Running Interference for TOW Launcher

Dear Editor,

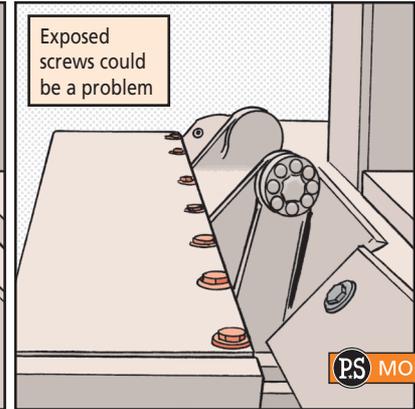
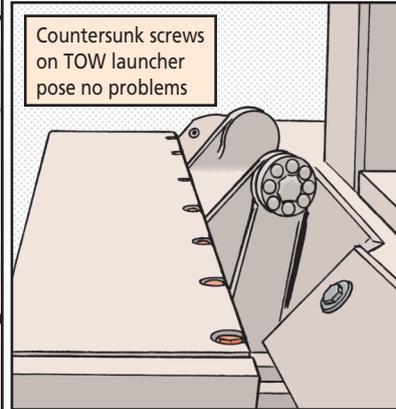
2. Check the screws attaching the armor plate, NSN 1005-01-110-7641, to the TOW launcher. Earlier versions of this armor plate used countersunk holes for the screws.

If the screws on the TOW launcher armor are countersunk, stop now. There is no interference problem. However, if the screws *aren't* countersunk, continue to Step 3.

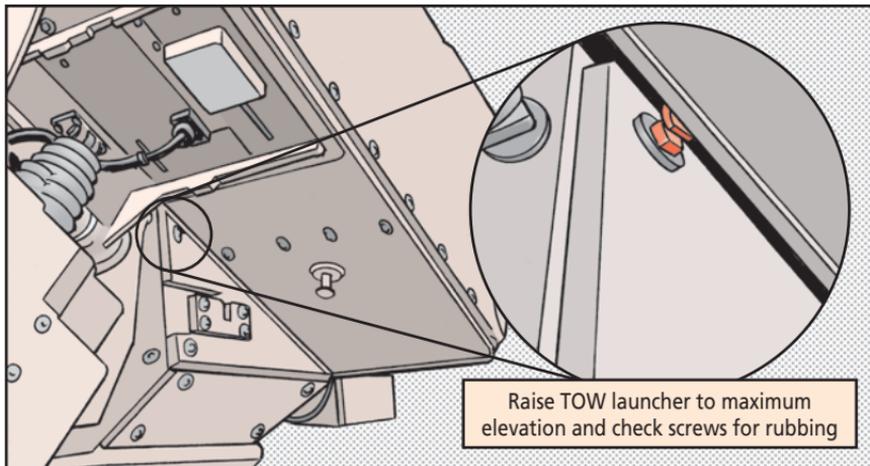
3. Raise the TOW launcher to its maximum elevation. Watch closely to see if the two screws hit. If they don't, stop here. If they do, continue to Step 4.

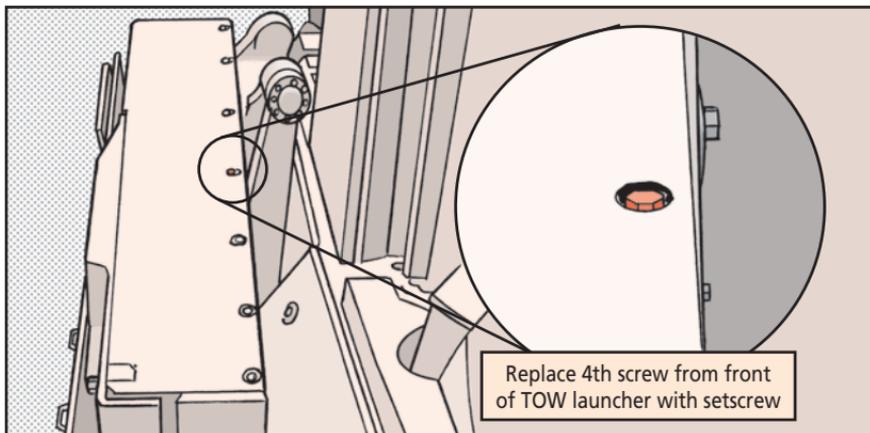
4. Remove the $\frac{3}{8}$ -in screw at the fourth position from the front of the TOW launcher. Replace it with setscrew, NSN 5305-00-724-5888. Coat the setscrew threads with sealing compound, NSN 8030-01-014-5869, to hold it in place.

Once installed, the setscrew is flush with the armor plate, eliminating the interference problem.
